Presentation to the ACRS Subcommittee

Safety Review of the Vogtle Early Site Permit Application

October 24, 2007

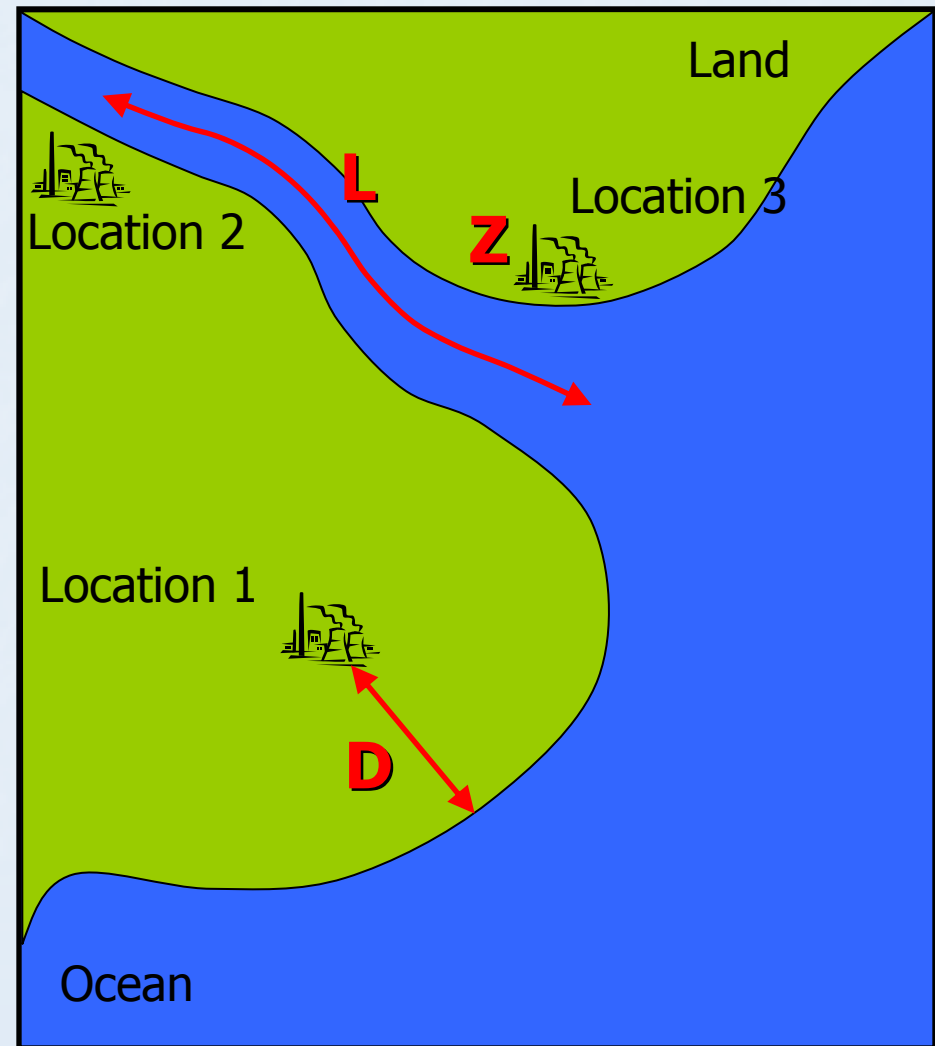
- Vogtle ESP Tsunami Assessment
 - Hierarchical review approach
 - step 1: regional screening
 - step 2: site screening
 - step 3: comprehensive tsunami hazard assessment (THA)
 - step 1: regional screening
 - Historical tsunami runup information from National Geophysical Data Center (NGDC)
 - Existing tsunami runup events north and south of the Savannah River Estuary
 - Actual runup heights missing in the NGDC database; Charleston runup less than 1 ft; estimated runup on east coast of 10 ft from 1755 Lisbon earthquake and tsunami
 - The Savannah River Estuary is subject to tsunami events
